**SIB 34 01 07**

HP2-Cable Tie Damages Anti-Chafing Pad at Brake Hose - Bulletin 34 001 07 (010)

Subject: Cable tie damages anti-chafing pad of the rear brake hose

Model: HP2 Enduro (K25HP)

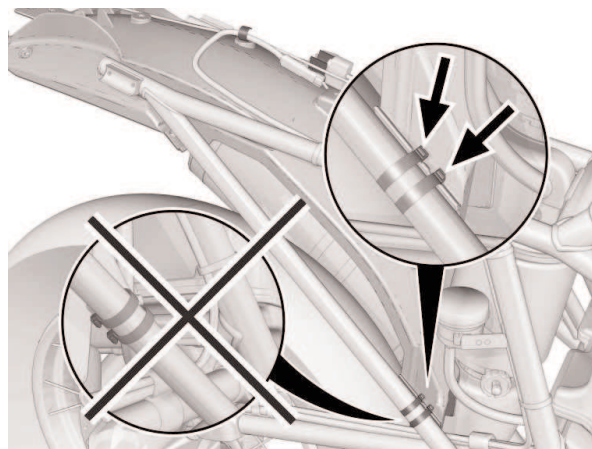
Details: When the rear suspension approaches full compression, the cable ties that secure the rear mudguard to the rear section of the frame can damage the anti-chafing pad of the rear brake hose.

Production Solution: On all currently produced HP2 Enduro models the two cable ties are installed turned to a position in which the head of the cable tie can no longer cause damage to the anti-chafing pad.

I. Cut the two cable ties open and install two new cable ties positioned with the **head of each cable tie to the outside** and against the rear mudguard (arrows).

II. Check the anti-chafing pad of the rear brake hose.
If the anti-chafing pad shows clear signs of significant damage the rear brake hose must be replaced. Make sure that the new hose is correctly routed (see RepROM).

It is not necessary to replace the brake hose if the anti-chafing pad is only slightly scuffed.
